Docket Item # 5  
BAR CASE #2009-0209

BAR Meeting  
November 4, 2009

**ISSUE:** Signage  
**APPLICANT:** Carr 625 First Street, LLC  
**LOCATION:** 625 First Street  
**ZONE:** CD/Commercial

Figure 4: Current Proposed Blade Sign

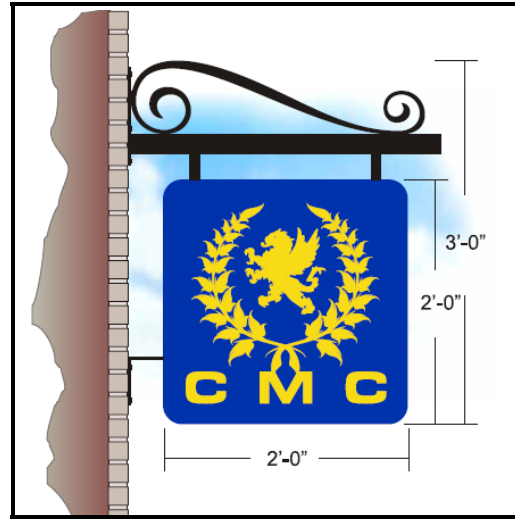
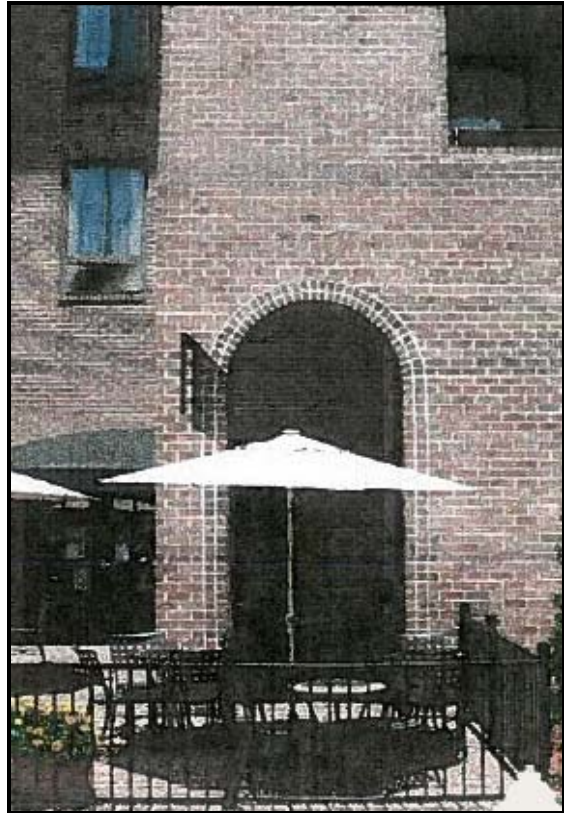
The current sign proposal has been only altered in one area since the previous BAR hearing. The applicant has deleted “Café Monte Carlo” from the hanging sign and replaced it with “CMC”. Staff is concerned that this design change will be confusing to a patron, who would be unsure what type of business the sign is advertising. Staff recommends that the hanging sign’s design be revised to reflect the original submittal.

1. That the bracket and wall signage be mounted to the building through the mortar joints.
2. That the hanging sign’s design is revised to include the text “Café Monte Carlo”.

Figure 6: Proposed Wall Mounted Sign

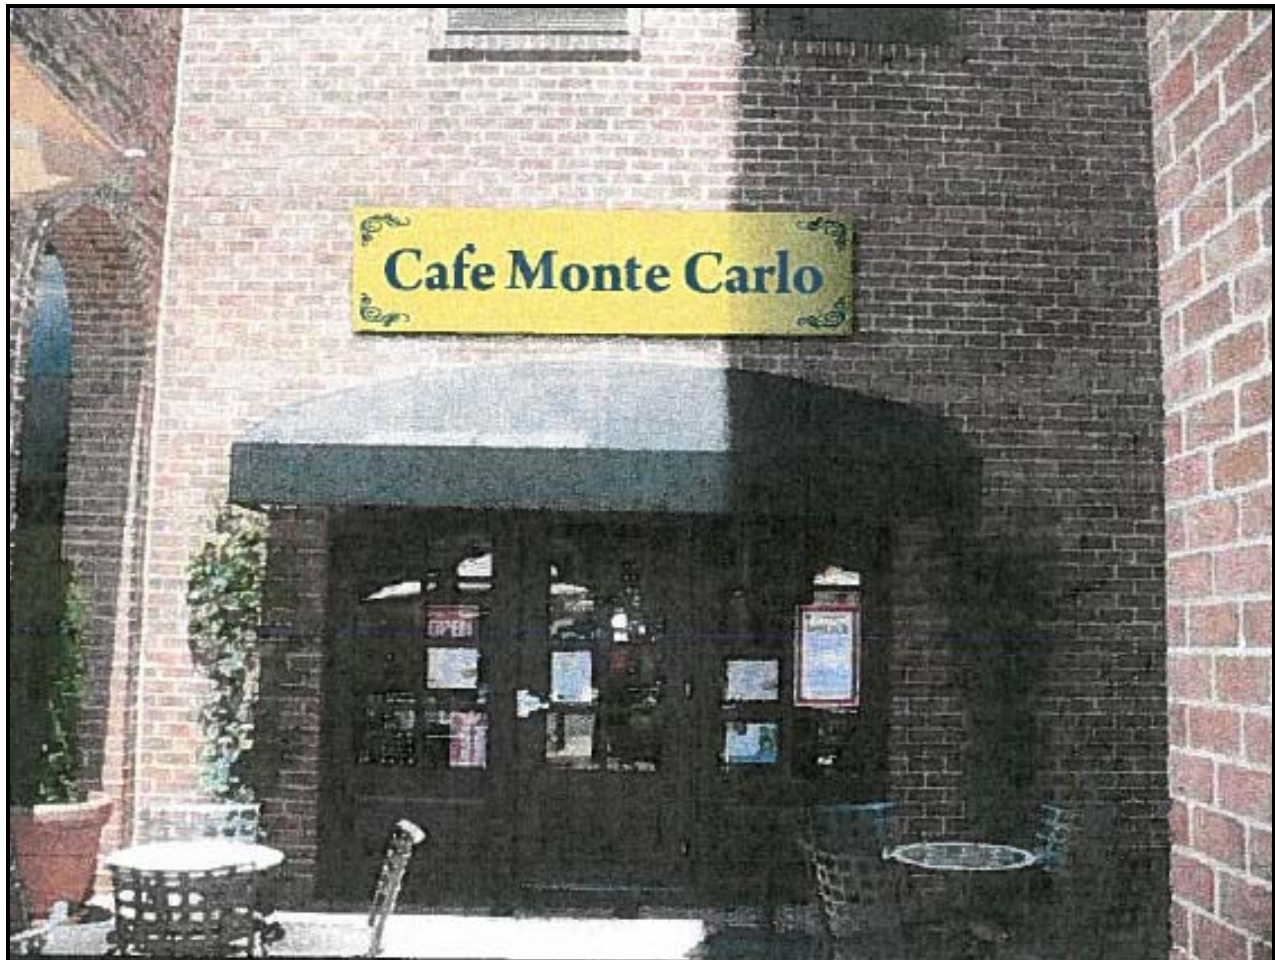
The applicant has provided the Board with the requested photo mock-ups showing the proposed wall sign from the oblique street view. The proposal for this wall sign has not been changed since the previous hearing as the applicant feels strongly that the size of the sign is needed for his storefront visibility. The applicant notes in the attached explanation (page 12) that the business currently has 73 feet of storefront which is setback 42 feet 8 inches from the sidewalk and the location of the café on a cul-de-sac provides a visibility challenge. Staff concurs with the applicant’s assessment of these visibility challenges. This storefront is located at the end of a street, recessed considerably from the public right-of-way. Beyond the hotel patronage, it would be extremely difficult to gain pedestrian traffic unless the storefront had two forms of signage, as proposed.

- 1) I have 73 feet of store front, I really think I should be allowed At least 2 by 8 feet sign ?
- 2) The side walk is 42 Feet and 8 inches from the storefront, I'M in an alcove or you could even call it cul de sac. Please view pictures taken from different angles.
- 3) The pan blade sign if made smaller, would result to using abbreviated CMC intials, which really looks tacky. The pan blade sign, looks very good with complte name of the restaurant. Please do remember I'm approximately 43 feet away from the side walk.
